**APPENDIX E:**  
**ADDITIONAL INFORMATION PROVIDED BY CASTLEREAGH COAL**

1. Response to Department and Agency comments on RTS, dated 10 May 2017
2. Final Landform Options, dated June 2017
3. Additional assessment of impacts on conservation values, dated July 2017
4. Response to EPA comments on draft conditions, dated 18 October 2017

**Re: Invincible Southern Extension Project, Additional Information Required for Assessment**

FIGURE 1

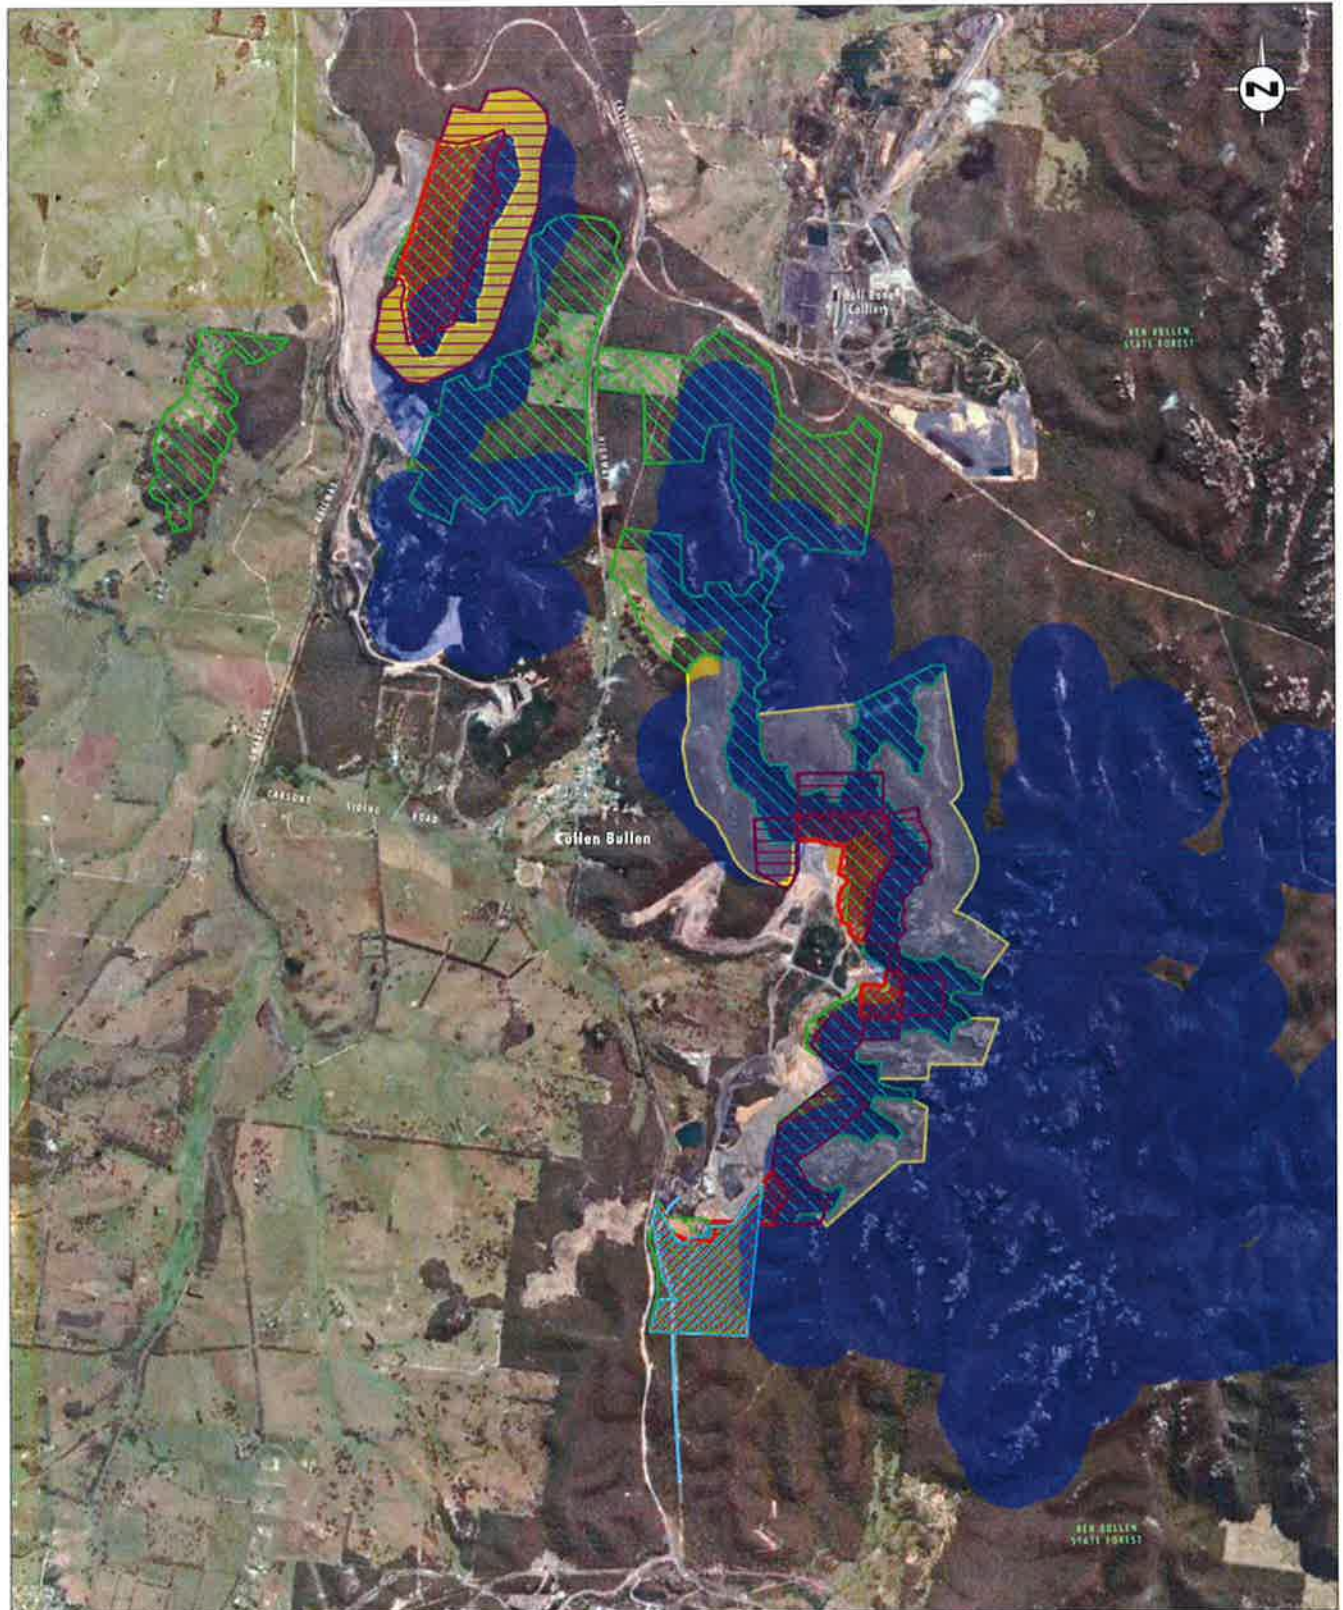
***Further justification for the proposed mine plan is required including consideration of options to avoid open cut mining within 300 metres of pagodas and other associated geodiversity features, including escarpments.***

***This consideration should include the quantity of coal that would be sterilised, including 'nut coal', and the economic costs associated with avoidance. The justification may also include consideration of other operational constraints of avoidance including implications on scheduling and rehabilitation.***

Of critical importance, is that the location and design of the Southern Extension Project has sought, to the extent practicable, to avoid and minimise impacts on pagodas and other structures in proximity to Invincible. As discussed in Section 1.3 of the EA, previous assessment findings and submissions from agencies and other stakeholder groups were taken into account in selecting the SEA as the preferred mining area. Environmental constraints studies and mine design work were also undertaken to refine the mine plan for the SEA. As detailed in Section 3.7 of the EA, as part of the detailed constraints review, the Southern Extension Project has been located and designed to minimise impacts whilst still achieving the objective of a reliable supply of nut coal to Shoalhaven Starches. Key considerations included the location of the proposed mining to the south, which represents a less geo diverse landscape relative to the landscape to the north and east of Invincible, as well as a reduction in the north eastern extent of open cut mining in the SEA in this as previously proposed as part of the Modification 4 application (refer to Figure 1.3 of the EA).

In the context of pagodas and other geodiverse structures, the location and design of the Southern Extension Project results in just 6 hectares of the total 49 hectares (or 12%) of the SEA being located within 300m of these structures. As shown in **Table 4**, this represents a significant reduction in the areas of proposed mining within 300m of these structures relative to previous proposals (refer to **Figure 1**).

FIGURE 4

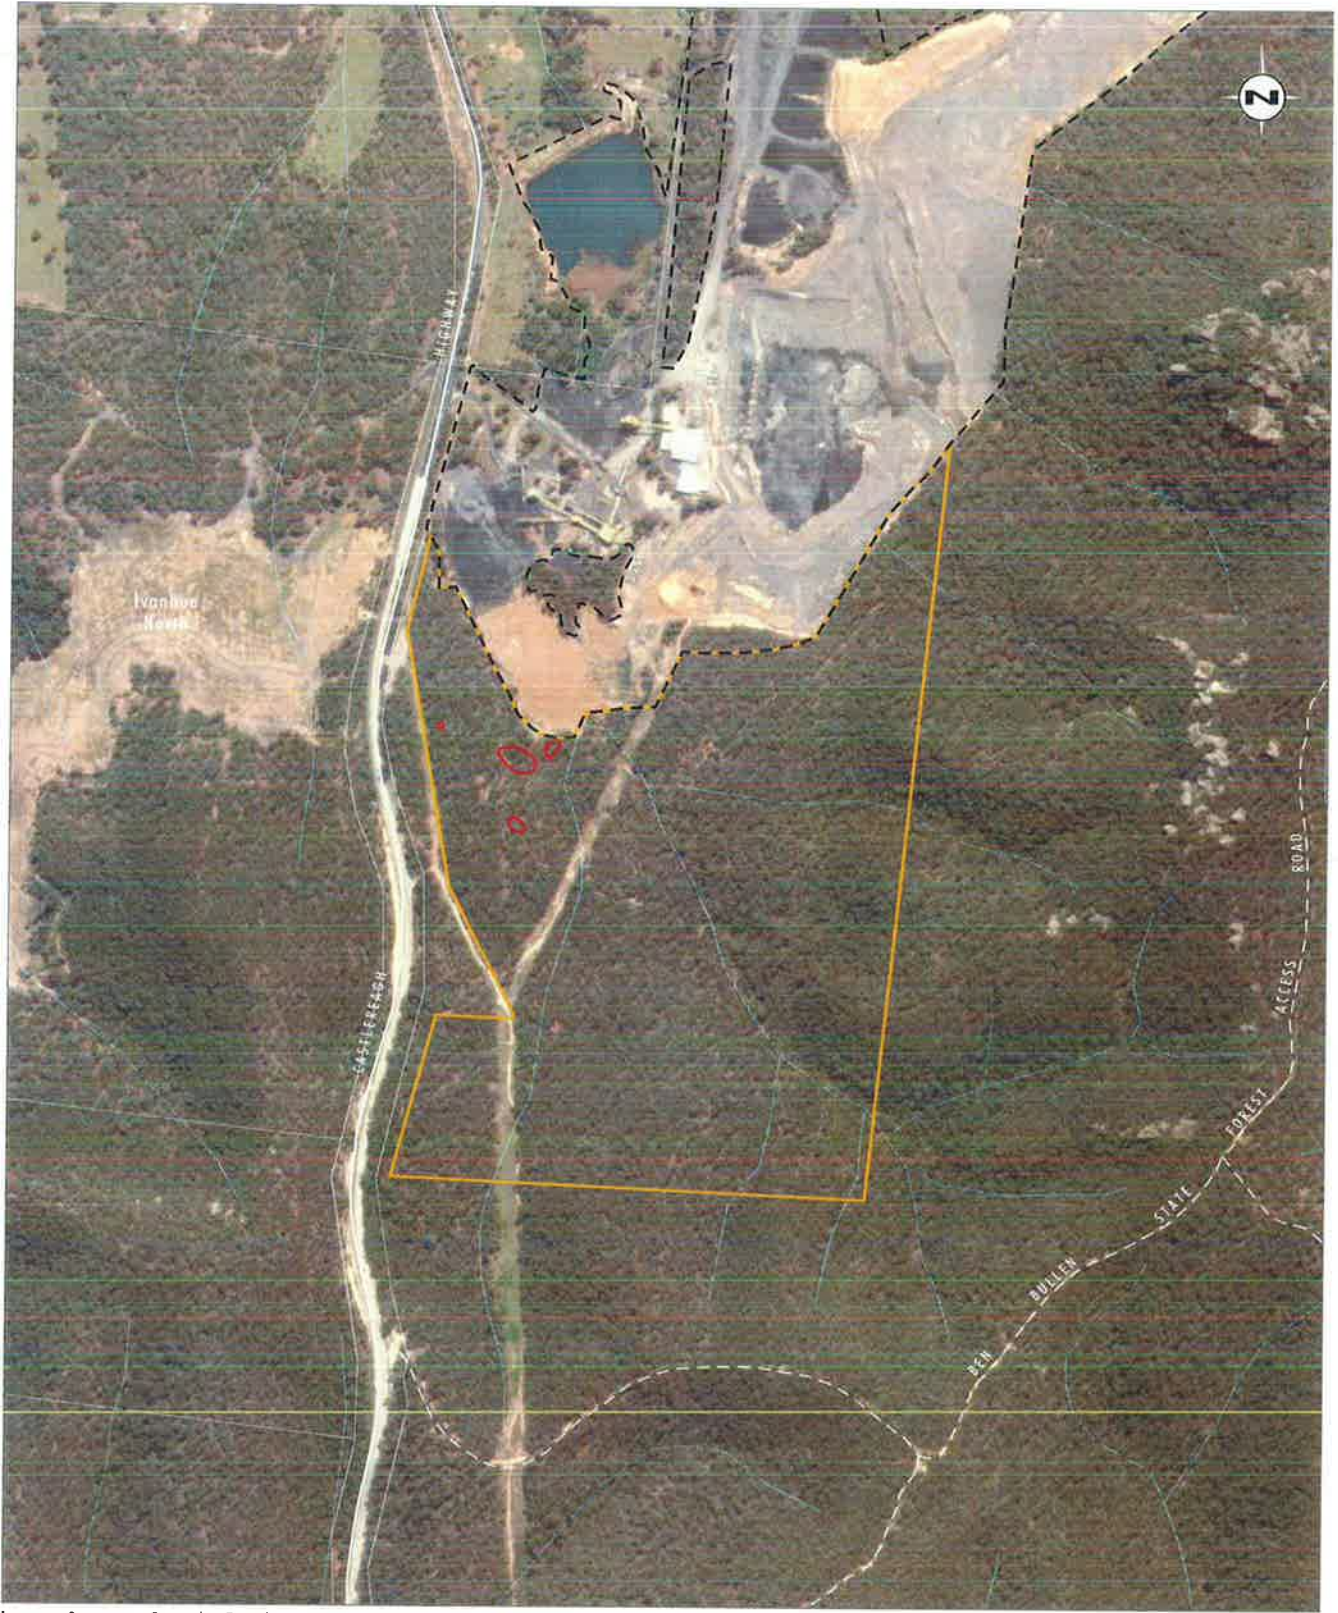
***Additional surveys for Eucalyptus cannonii should be undertaken in the areas identified in accordance with the NSW Guide to Surveying Threatened Plants.***

***Firstly, the proponent has not undertaken the additional survey recommended by OEH to determine the total number of E. cannonii trees present. The proponent claims to have conducted surveys consistent with the NSW Guide to Surveying Threatened Plants (OEH 2016) guidelines however the proponents survey effort figure does not demonstrate the systematic parallel transects required by the guideline. The guidelines specifically state that the use of plots and random meander searches (both used by the proponent) are not adequate to meet the guideline.***

Notwithstanding, an additional survey for *E.cannonii* has been undertaken across the entire SEA on 5 April 2017 in response to the matters raised by OEH. Two ecologists walked parallel transects (maximum of 40 metres apart) across the SEA in accordance with the *NSW Guide to Surveying Threatened Plants* (OEH 2016) searching for *E. cannonii* (refer to **Figure 3**). For completeness, **Figure 3** includes all walking tracks completed for this species across the multiple survey periods, which clearly demonstrates coverage of the SEA.

Based on the most recent survey, an additional 12 *E.cannonii* individuals were recorded taking the total number recorded across the SEA to 36 (refer to **Figure 4**). The FBA calculator for the project has been amended with the additional records and the credits required to offset this species has changed from 312 to 468 (refer to the response below on the Biodiversity Offset Strategy). As described previously, preliminary offset surveys undertaken in the Hillcroft property( which is proposed as a BioBank site) is expected to generate sufficient credits for this species. Further detailed survey and assessment of the Hillcroft property in relation to *E. cannonii* will be undertaken during the development of the final Biodiversity Offset Strategy to confirm species credit offset requirements are satisfied.

**FIGURE 2.1**  
**Conceptual Final Landform**  
**Option 1: Reduced Slope Treatment**

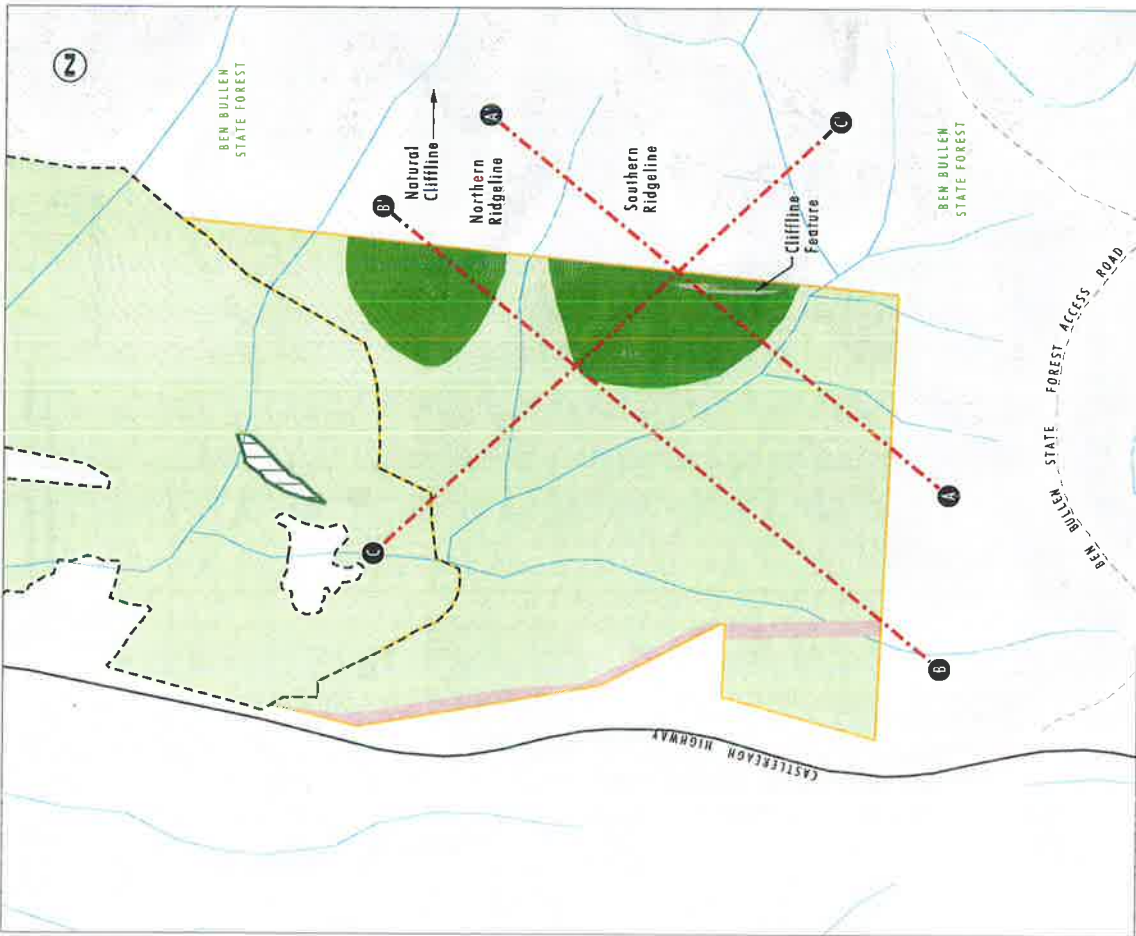
The concerns raised by DP&E relate to the steeper south, south western facing slopes on the ridgelines in the eastern parts of the conceptual final landform proposed for the Southern Extension Area (refer to **Figure 1.1**). DP&E's focus on these areas is understood to relate to concerns that the rehabilitation of these areas may be subject to similar constraints as those which applies to the West Pit area. As noted in **Section 1.2**, the landform shown in **Figure 1.1** (see also Figure 3.4 from the EA) is conceptual only and is subject to detailed rehabilitation design considerations to be incorporated into the MOP. As discussed in **Section 1.3**, the surplus overburden generated by the Southern Extension Project provides the flexibility in revising the landform to achieve long term stable landforms across the Southern Extension Area and the remaining areas of the Invincible Open Cut disturbance area yet to be fully rehabilitated. The following sections discuss different options regarding possible landforms and evaluate the merits and disadvantages of each of the potential rehabilitation options, including the avoidance of mining of steeper slopes as requested by DP&E.

**Option 1** This is the EA Conceptual Final Landform with landforms developed to reduce slope gradients on the eastern side of the Southern Extension Area through the use of surplus overburden from the Southern Extension Project (refer to **Section 1.3**). The landform in the south and west of the Southern Extension area will be reinstated to a landform similar to the pre- mining landform. This option is shown in **Figure 2.1**.

FIGURE 3

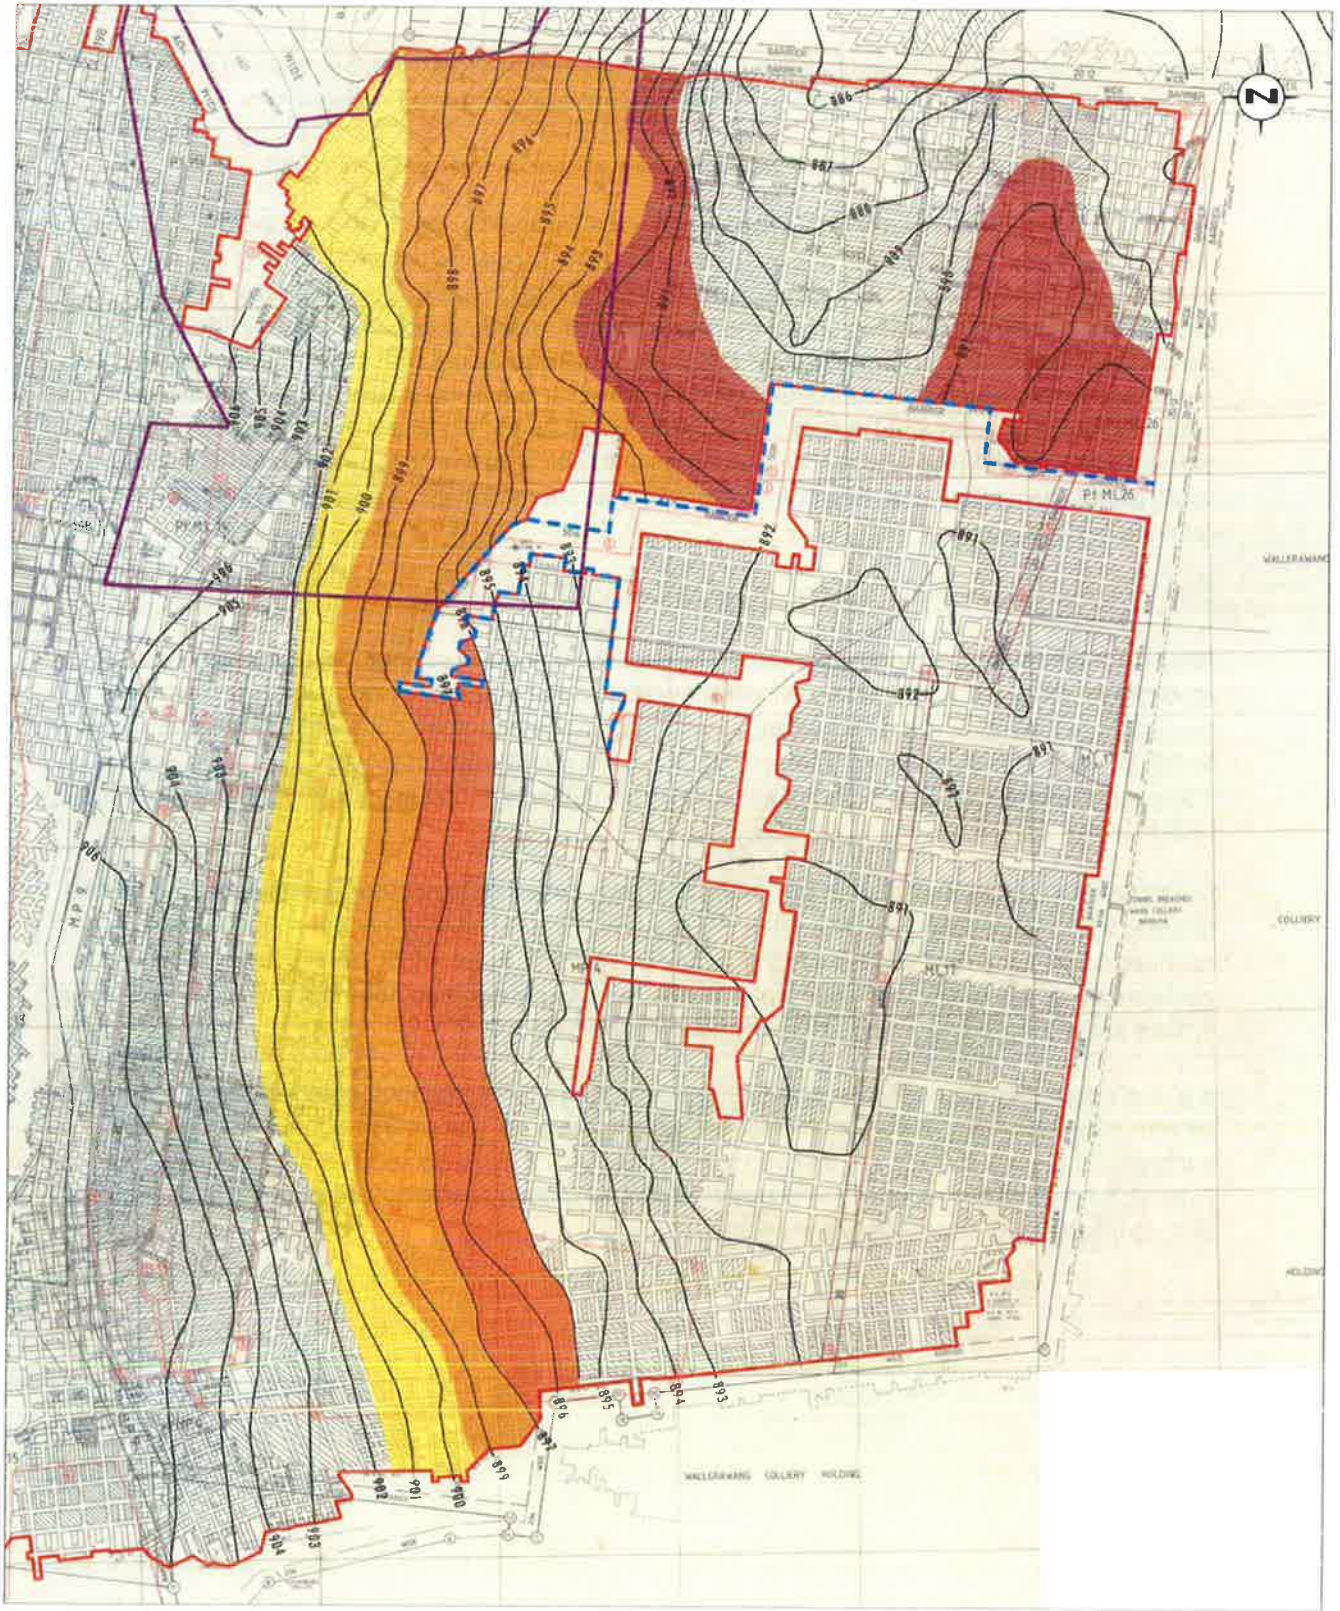
Following the EPA letter dated 13 September 2017, the data used to assess the stored water in the Ivanhoe No. 2 workings has been further reviewed and updated to provide further certainty to the calculation of water volume in these workings that would require dewatering for the Southern Extension Project. In addition, the assessment of the volume of available storage in the former Invincible underground workings has also been reviewed.

Given the accuracy of the Record Tracings, updated estimates of the extent of water in the Ivanhoe No. 2 workings have been completed. This process has identified that the area of workings flooded is larger than previously understood with the extent of flooding extending to the southern extent of the workings and not just the north eastern corner as had previously been understood. The extent of inferred flooding is shown in **Figure 3**.

On the basis of the additional data obtained through the Record Tracings, a remnant barrier of coal in the south-eastern corner of the Southern Extension Area operates as a dam for water stored below RL 898m AHD, south of this barrier (refer to **Figure 3**). Based on this information, this barrier will be retained and not be mined as part of the Southern Extension Project, subject to further detailed mine planning and approval process with the Resources Regulator (refer to **Section 2.8**). The retention of the barrier to the south east will reduce the volume of water to be removed and ensure that the outcomes of the assessment are met (i.e. water from Ivanhoe No 2 workings is captured and stored within the former Invincible underground workings). It is noted that this will result in some Lithgow and Lidsdale seam coal in this area being sterilised.

- The existing coal barrier in the Ivanhoe No 2) workings (as shown in **Figure 3**) will initially be retained, meaning water below 898m AHD to the south of the barrier will not need to be dewatered (refer to discussion in **Section 2.5**). For the purposes of calculations, water above a head of 898m AHD in the areas south of the Barrier (i.e. areas with a seam floor level of between 896AHD and 898m AHD) will be removed as part of the dewatering process. Following dewatering, approximately 50% of the water currently in the void space in the areas where seam floor levels south of the Barrier are between 896m AHD and 898m AHD (refer to **Figures 3 and 4**) will be removed.

As noted above, the review of the RTs has identified an internal barrier in the Ivanhoe No. 2 workings (refer to **Figure 3**). As also noted above, this process of further detailed mine planning and removal of old workings would be subject to the approval processes of the Resources Regulator (refer to **Section 2.8**). The original mine plan for the Southern Extension Project would have resulted in the partial removal of this barrier however, if retained, the barrier would limit the amount of water needing to be removed from the Ivanhoe No 2 workings. It is proposed to retain a 50m barrier in this area in both the Lithgow and Lidsdale Seams (refer to **Figure 3**). The effect of the retention of the barrier is that water in the Ivanhoe No.2 workings will have a static head at RL 898m AHD to the south of the barrier; and as such water stored below RL 898mAHD to the south of the barrier will be retained in the workings.
